Planning and Zoning Commission

Village of Homewood

May 28, 2026

Topic: Cases 26-08, 26-33 and 26-37: Special Use Permit, Variance and Site Plan Review for 7Brew Drive-Through Coffee Shop at 17855 Halsted Street

Parking Lot Perimeter Landscaping

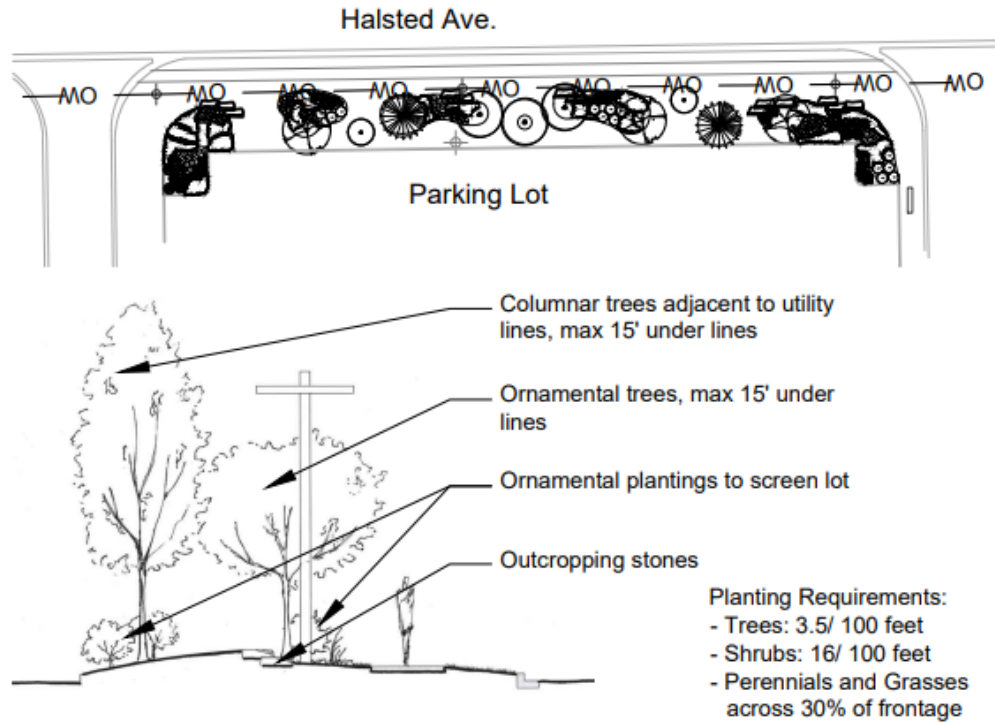
The applicant is required to provide a minimum 15’ wide landscape area along Halsted Street as a parking lot perimeter landscape area. This area shall be located between parking spaces and the property line adjacent to the right-of-way of Halsted Street. The frontage of perimeter landscaping required is 210’ (existing parking areas remaining after construction are not required to add new perimeter landscaping). This landscape area shall meet the following requirements:

- For every three feet, one shrub or native grass shall be provided – **met required, 57 shrubs and additional native grass areas provided.**
- For every 25’ of landscape area length, one understory/evergreen tree shall be provided – **met, 9 provided, 8 required**
- For every 25’ of landscape area length, one canopy tree shall be provided – **not met, 7 provided, 8 required**
- The remainder of landscaped area outside of shrubs/plantings shall be planted with live groundcover – **met, multiple groundcovers provided**

The applicant has also provided a perimeter landscaping area which is narrower than the required width for the landscaping area (11’ 7” vs. 15’). The applicant has submitted a variance for this reduction in required width, which is reviewed in detail in this memo. The proposed perimeter landscape area meets Village standards, provided the following conditions are met:

1. **The Planning and Zoning Commission and Village Board approve a request for a variance to reduce the required width for the perimeter landscape area from 15’ to 11’ 7”**
2. **The applicant submits a revised landscape plan which incorporates preferred species from the Village Arborist and replaces one (1) understory/evergreen tree with one (1) canopy tree.**
3. **The applicant submits a revised landscape plan with a full plant list pursuant recommendations of the Village Arborist, including native grasses and groundcovers.**

7 BREW HOMEWOOD
Site Plan

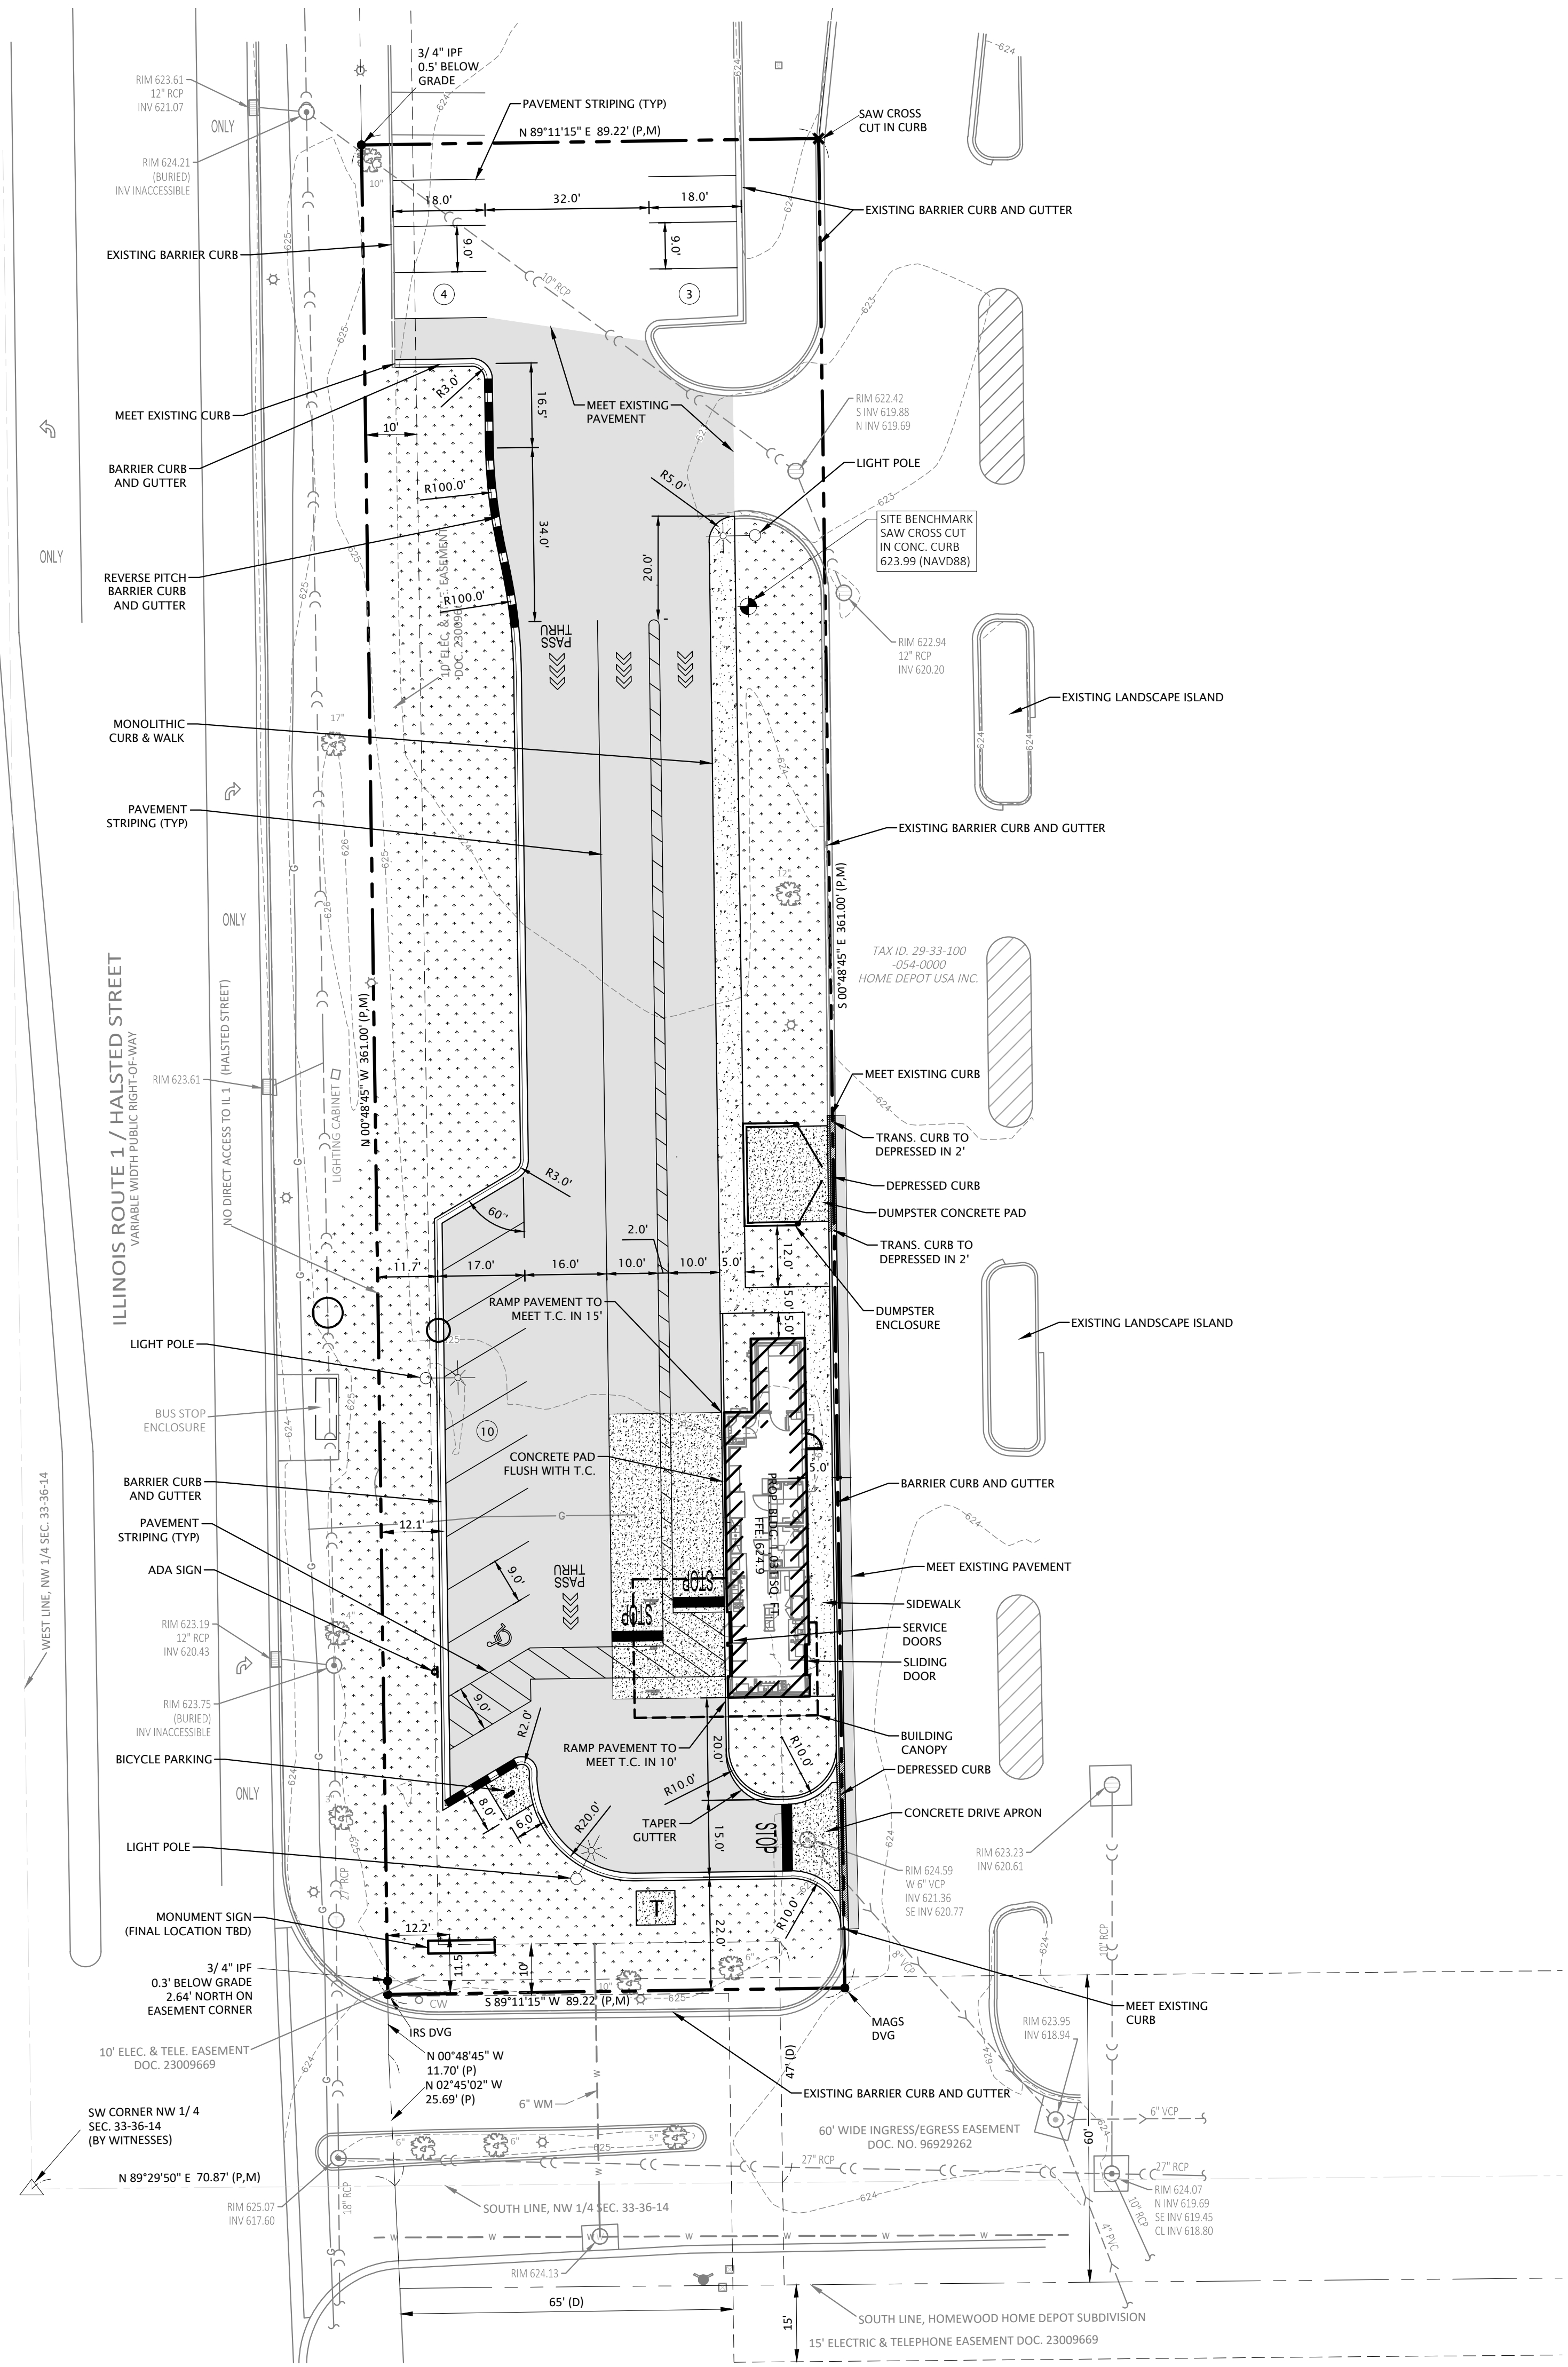
The applicant will construct a 1,031 square foot building to support a drive-through coffee shop business. The building will be served by two drive-through lanes bringing traffic from the north up to the building. Customers in the drive-through lanes will be served from two large sliding doors in the building where employees can enter and exit the building and walk to customers in vehicles. A pass-through lane will be provided to the west of the drive-through lanes to provide access to parking for employees. Additional parking will be provided on the north side of the site where existing parking is currently located. A large landscape median will be provided between the new aisles and the private drive located to the east of the site.

- **Design and Layout:**
 - Provide minimum 6” curbs **(met)**
 - All curb cuts and drive aisles shall be approved by the Village Engineer **(met)**
- **Stacking**
 - Minimum 6 spaces of stacking per order box – **12 required (met)**
 - Minimum 10’ stacking lane width **(met)**
- **Menu Boards**
 - No menu boards proposed
- **Overhead Canopy**
 - No greater than 20’ canopy height **(met)**
 - Canopy shall be uniform in height and maintain consistent roofline with building **(met)**
 - Exterior cladding shall be consistent with the primary building **(met)**
- **Screening from residential use**
 - No residential use
 - Village Engineer or Economic and Community Development may recommend additional screening based on impacts on public streets or access drives **(no additional concerns)**

Approve Case 26-08: Site Plan Review for proposed restaurant development at 17855 Halsted Street, subject to the following conditions:

1. The applicant submits a revised landscape plan which incorporates preferred species from the Village Arborist and replaces one (1) understory/evergreen tree with one (1) canopy tree.
2. The applicant submits a revised landscape plan with a full plant list pursuant recommendations of the Village Arborist, including native grasses and groundcovers.
